ADVISORY HOTLINE FIX

Group: 33 – Front Suspension	**Original Date: 16th August 2019**	**No. MQ33-001, MR33-001, QE33-001**
Model: MQ/MR Triton, QE Pajero Sport	**Subject: Change to front stabiliser bar linkage torque setting.**	
Revised on 20/09/2019 ..... (date) **Revised on** ..... (date) **Revised on** ..... (date)	Neil Dunn Head of Service Service Operations	Neil M Dunn
MMAL Ref P4929	**Document consists of 2 pages.**

(1) **Subject**: Change to front stabiliser bar linkage torque setting.

INSTALLATION SERVICE POINT
>>A<< STABILIZER BUSHING INSTALLATION

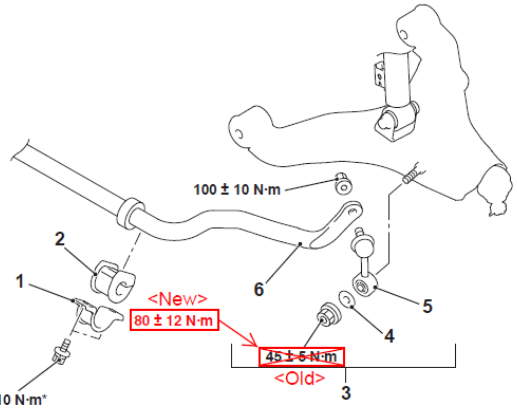
(2) **Possible Concern:** Due to rotational torque applied to the front stabiliser linkage during front suspension actuation, the stabilizer linkage retaining nut may loosen during service.

(3) **Production Fix**: Revised stabiliser linkage retaining nut torque settings applied from December 2018 production.

(4) **Field Fix**: As per the vehicle's maintenance schedule, please ensure to "Check suspension system for damage and looseness" during periodic maintenance. If the stabiliser bar linkage retaining nuts are found to be loose, please re-tension as per the revised specification (Refer to Service Bulletin 33-2019-003 for further details). If the retaining nut/s are found to be missing, please replace the nut/s and torque to the revised specification.
